Office Action Summary

10/570,821

BECKER-WEIMANN, KLAUS

DETAILED ACTION

Figure 1

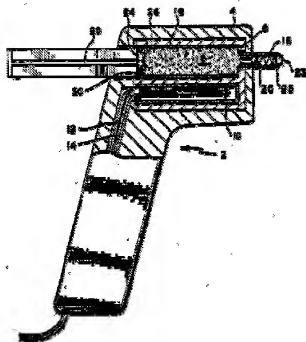
9. In Re claim 10, with reference to figure 1, and the specification, Belanger et al (US Patent 5,026,187) discloses

a. An adhesive fluid dispensing device (2) with an adhesive fluid dispensing tip (18) to which a flow from an adhesive fluid cartridge passes (6), and a manually actable adhesive fluid cartridge actuating ram (28), the adhesive fluid cartridge being assigned a heating cartridge (10) for heating the adhesive fluid

(8) to a temperature sufficient for flow to pass through an adhesive fluid dispensing tip (18) upon actuation of a ram, wherein the heating cartridge (8) is not in direct contact with the adhesive fluid dispensing tip (18), and the dispensing tip is composed of readily heat-conductive material (column 4, lines 32-35).

10. In Re claim 11, with reference to figure 1 below, Belanger et al. (US Patent 5,026,187) discloses

a. An adhesive fluid dispensing device (2), wherein the dispensing tip (18) is heated substantially just by the adhesive fluid flowing out.

11. In Re claim 12, with reference to figure 1, and the specification, Belanger et al (US Patent 5,026,187) discloses

a. The adhesive fluid dispensing device (2), wherein the dispensing tip (18) is heated substantially just by the adhesive fluid (8) flowing out.

12. In Re claim 15, with reference to figure 1, and the specification, Belanger et al (US Patent 5,026,187) discloses

a. The adhesive fluid dispensing device (2), wherein the ram (28) acts on the plunger (24).

13. In Re claim 21, with reference to figure 1, Belanger et al (US Patent 5,026,187) discloses

a. An adhesive fluid dispensing device (2), wherein power is supplied by electric current (14).

Figure 2

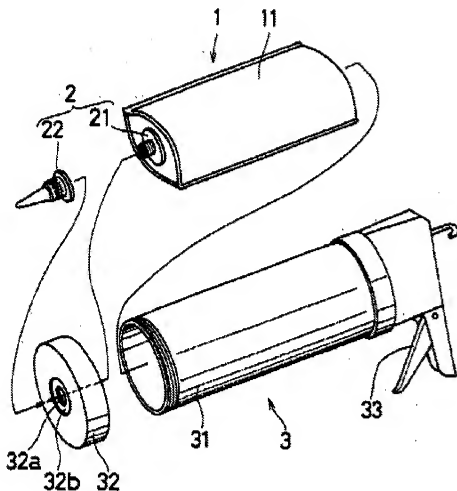
17. In Re claim 13 and 14, Belanger et al. has been discussed above, but doesn't disclose an adhesive fluid dispensing device, wherein the adhesive fluid cartridge is composed of metal and onto a metal thread on the dispensing device. However Miyata et al, with reference to figure 2 below, discloses an adhesive fluid dispensing device (3), wherein the adhesive fluid cartridge (1) is composed of metal and onto a metal thread (21) on the dispensing device. It would have been obvious to one of ordinary skill in the art to implement Miyata's teaching into Belanger's invention because this would allow the container to be emptied, cleaned and easily disposed of.

Figure 3

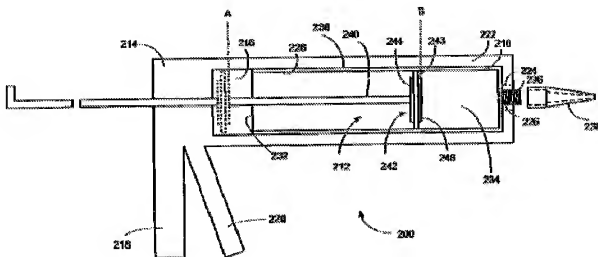
19. In Re claim 16 and 17 Belanger et al. has been discussed above, but doesn't disclose an adhesive fluid dispensing device, wherein the ram is assigned a pistol-type and pliers-type handle. With reference to figure 3 below, Osborn et al. discloses a pistol-

type and pliers-type handle (220). It would have been obvious to one of ordinary skill in the art to implement a pistol-type or pliers-type handle because this will provide the user better control when dispensing the contained fluid as well as comfort and less force needed to drive the ram.

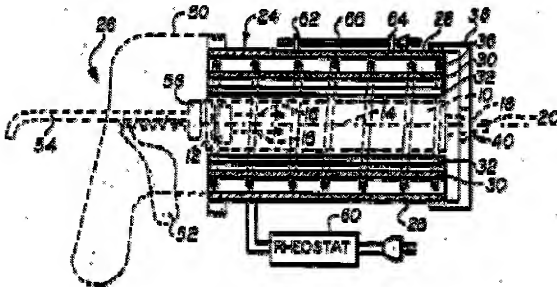
21. In Re claim 18 Belanger et al has been discussed above, but doesn't disclose an adhesive fluid dispensing device, wherein the heating cartridge is arranged around the cartridge. With reference to figure 4 below, Feldman does disclose a heating cartridge (10) that is arranged around the cartridge. It would have been obvious to one of ordinary skill in the art to implement a heating cartridge that is arranged around the cartridge because this would insulate the fluid prevent initial clogging of the adhesive through the

extrusion nozzle. Furthermore, by arranging the heating cartridge around the adhesive cartridge less time would be needed to melt the adhesive reducing waiting time

22. In Re claim 19, Feldman teaches an adhesive fluid dispensing device, wherein the heating of the cartridge content takes place from diametrically opposite sides as shown in figure 4 (shown below).
